# HISTORIC AND DESIGN REVIEW COMMISSION

**HDRC CASE NO:** 2015-254  
**ADDRESS:** 200 / 223 S ALAMO ST  
**LEGAL DESCRIPTION:** NCB 14016 BLK 9 LOT 14(0.082AC), 16(0.335AC), & S IRR 409.04 FT OF 15(0.36AC)  
**ZONING:** D HS RIO-3  
**CITY COUNCIL DIST.:** 1  
**LANDMARK:** Hilton Palacio de Rio Hotel  
**APPLICANT:** Robert Thrailkill  
**OWNER:** Zachary Corporation  
**TYPE OF WORK:** Exterior modifications  
**REQUEST:**

# HILTON PALACIO DEL RIO

HDRC SUBMITTAL FOR CONCEPTUAL APPROVAL

CANOPY | BIRD'S EYE VIEW

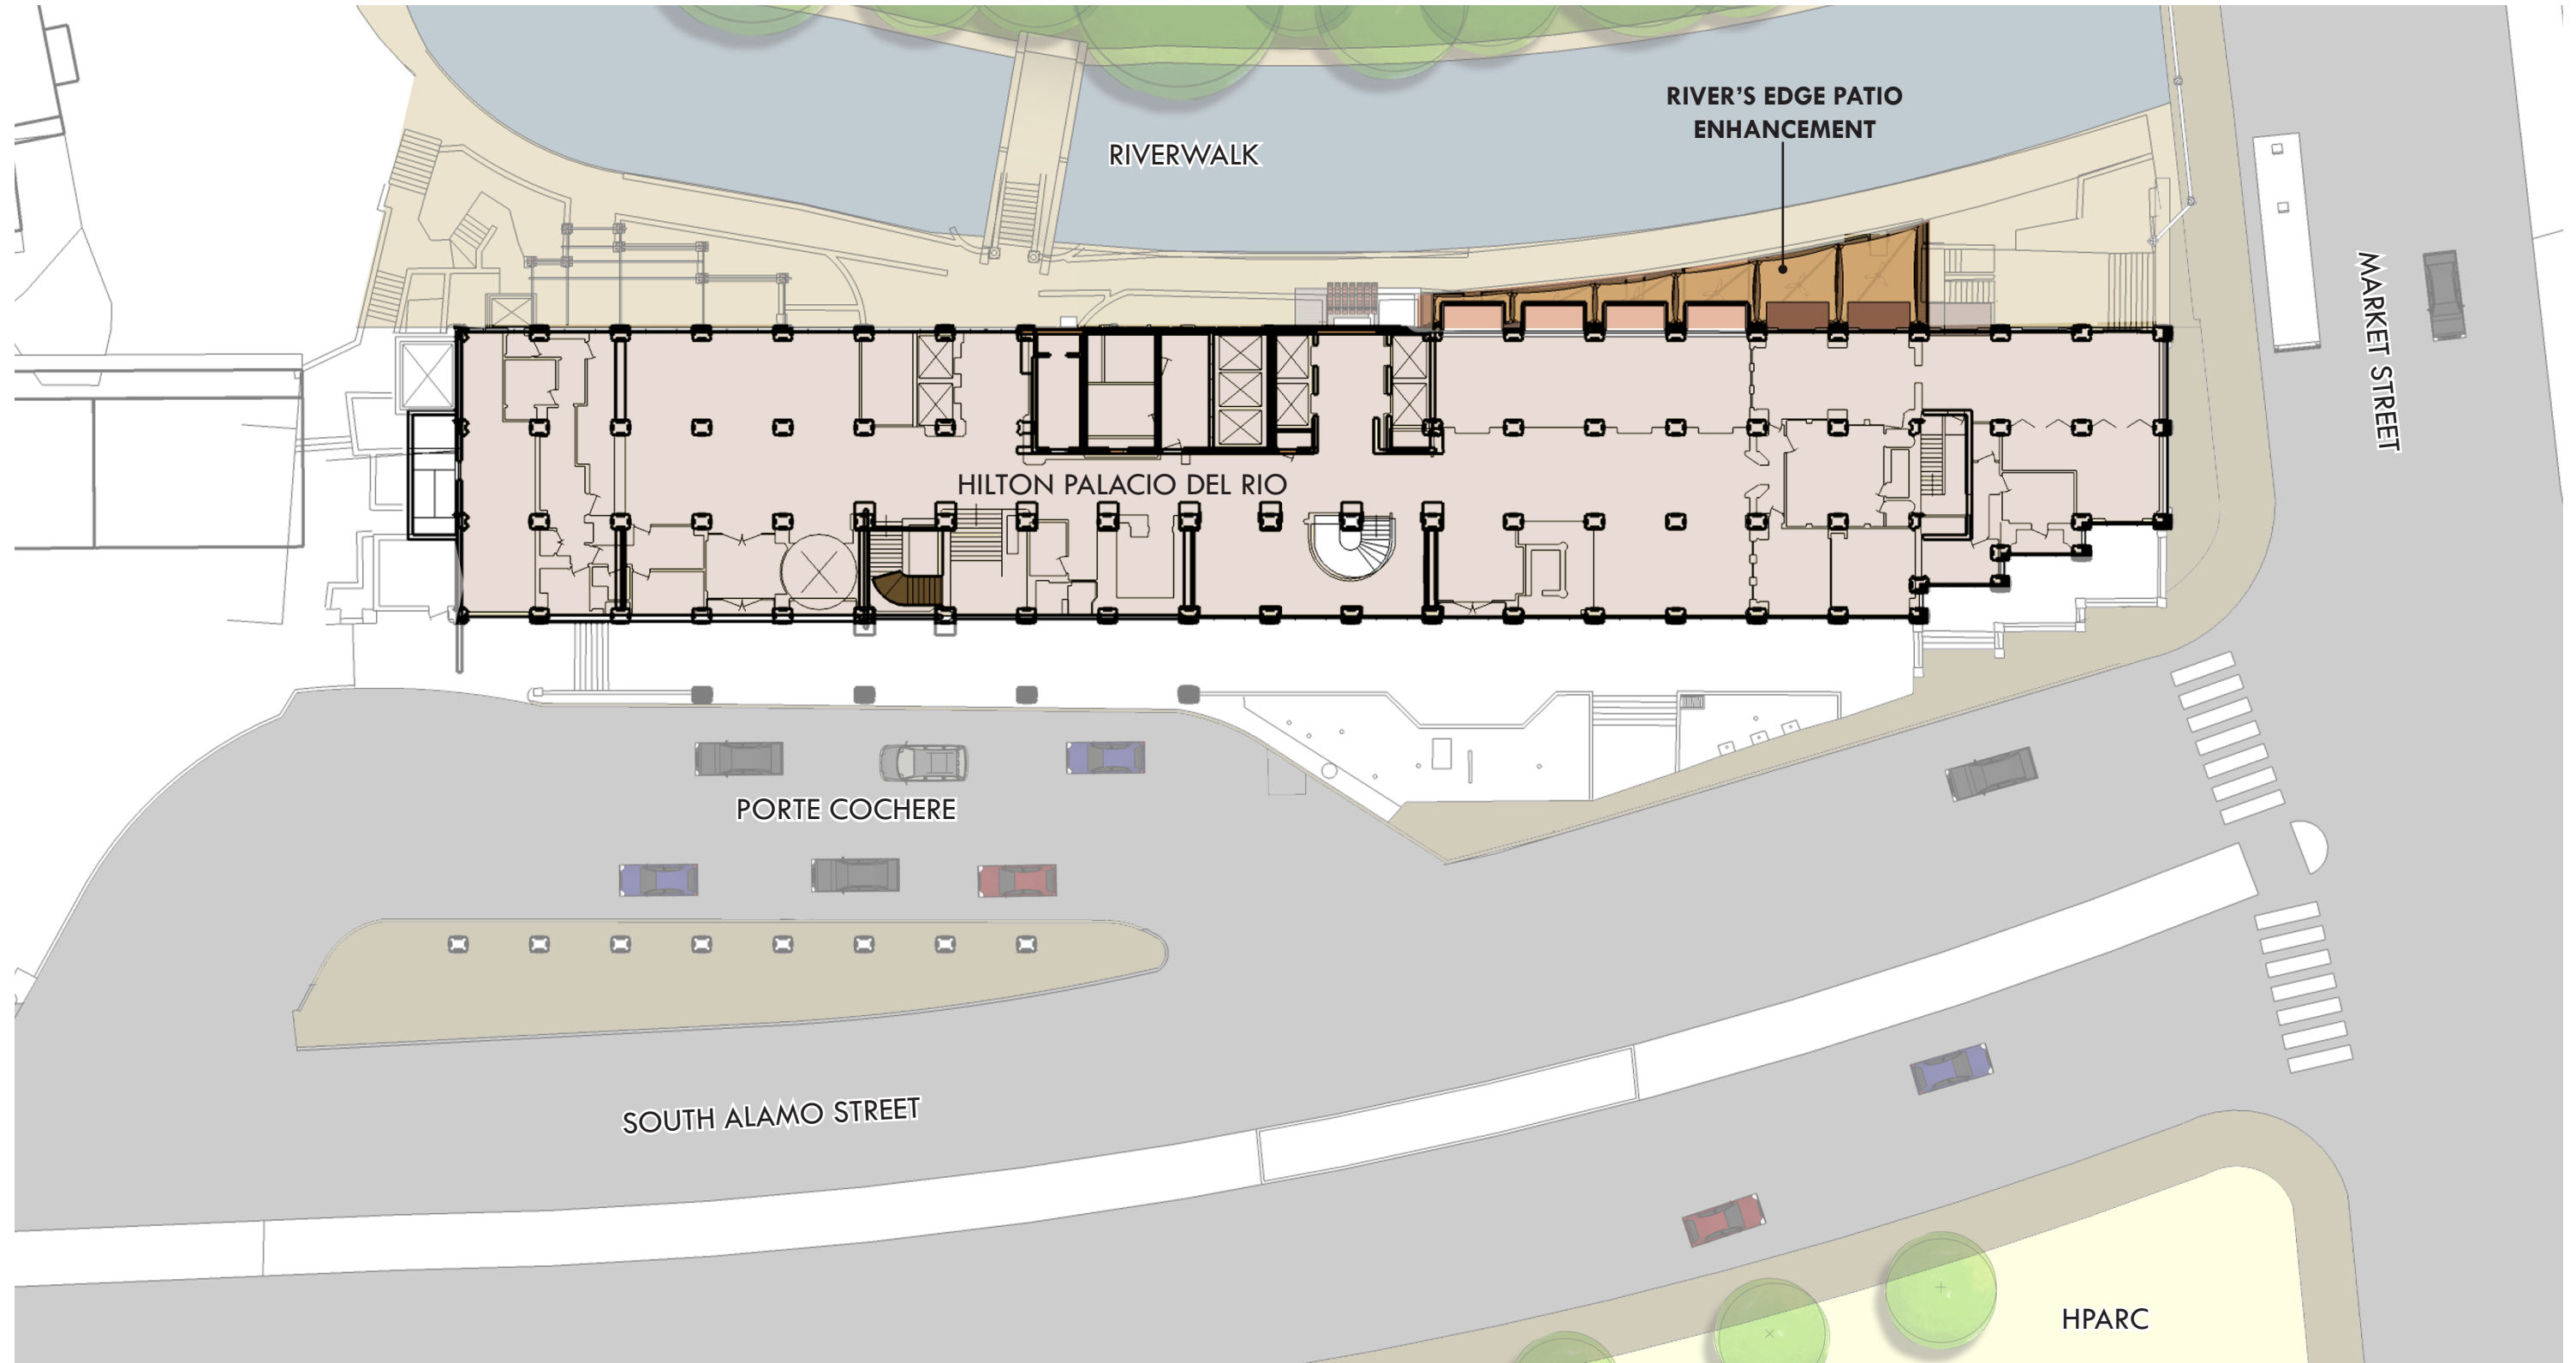
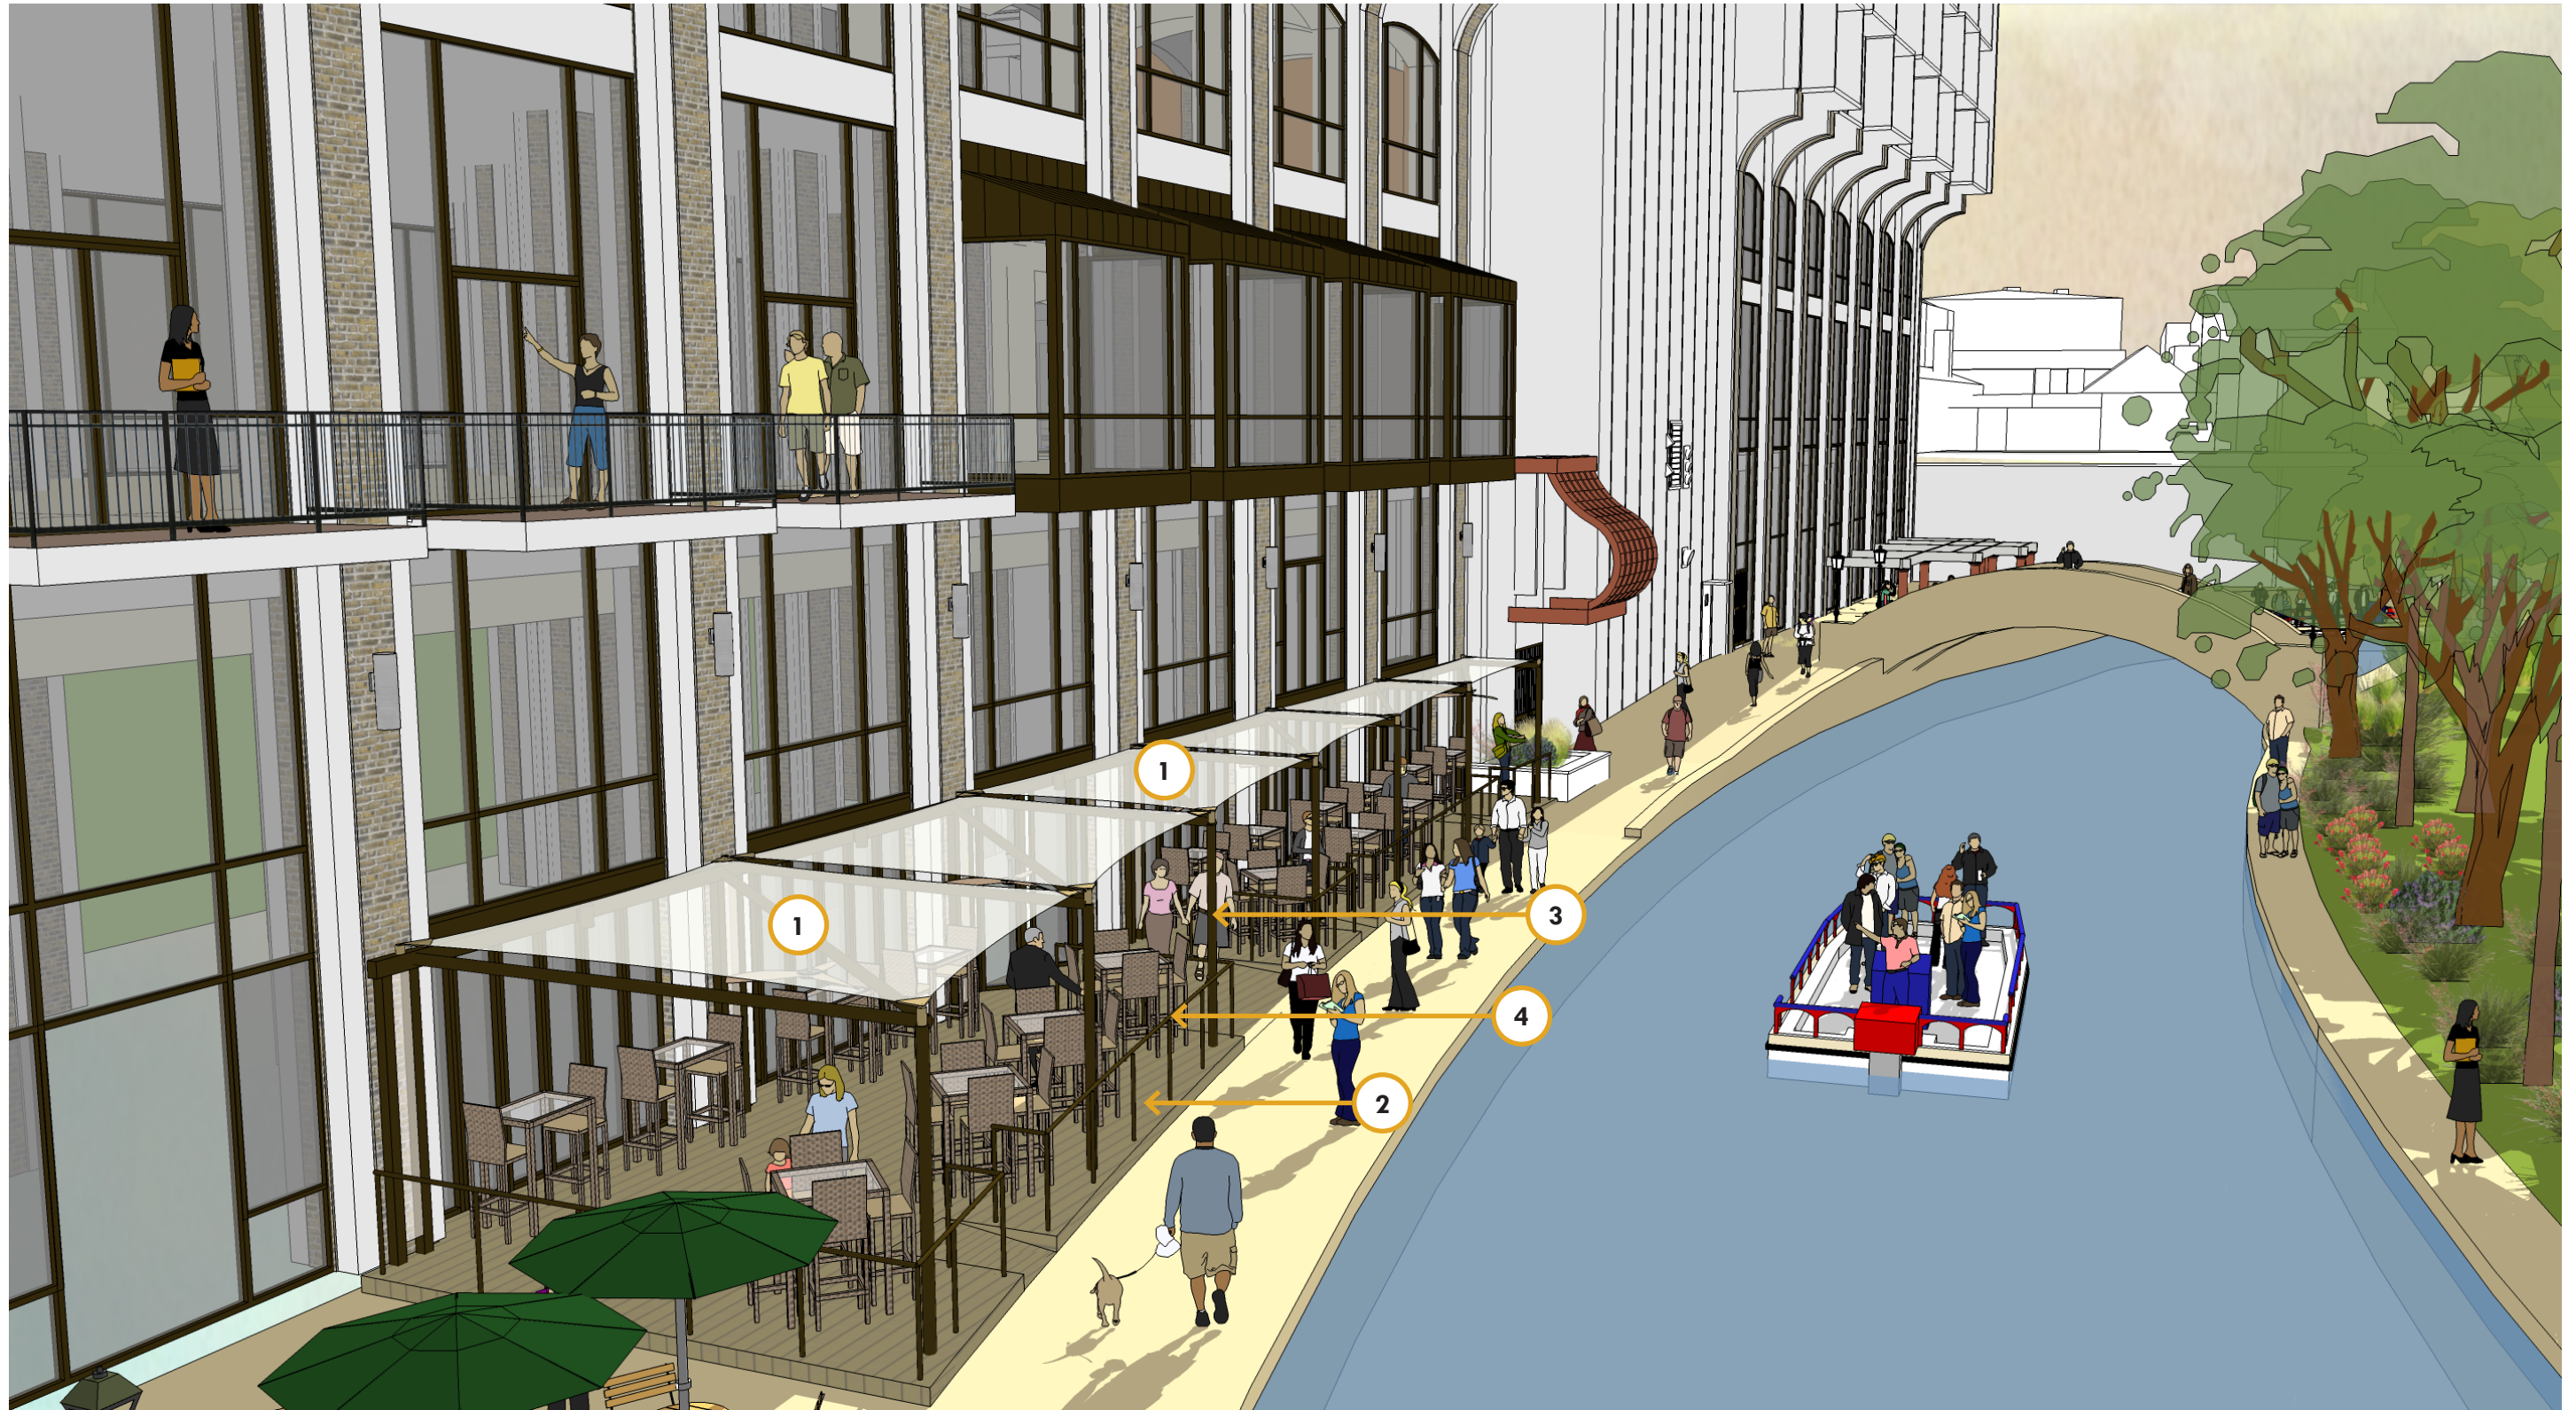
- c. The applicant has proposed a new outdoor canopy at the Riverwalk level that is to be composed of painted steel framing, painted railings, a fabric canopy and will feature ceiling fans for patron comfort. According to the UDC Section 35-674(g) regarding awnings, canopies and arcades, any awnings, canopy or arcade should be designed to accentuate the primary structure in form, proportions, materials, color and should include lighting that is incorporated into the design. The applicant's proposal is consistent with the UDC.

- d. Per the UDC Section 35-673(j)(1), site lighting shall be shielded by permanent attachments to light fixtures and for spaces adjacent to or visible from the San Antonio River should average ambient light levels of between one and three foot-candles with a minimum of 0.5 foot candles, should not produce light pollution greater than one half of one foot candle measured at any point ten feet beyond the property line and should feature a light temperature and color between 2500 K and 3500 K with a color rendition index (CRI) or eighty or higher. The applicant is responsible for complying with this section of the UDC.

- i. That the applicant provide more information regarding the proposed canopy lighting including specific materials, details and a lighting scheme.
- ii. That the applicant provide more information regarding the proposed concrete deck's final finish.
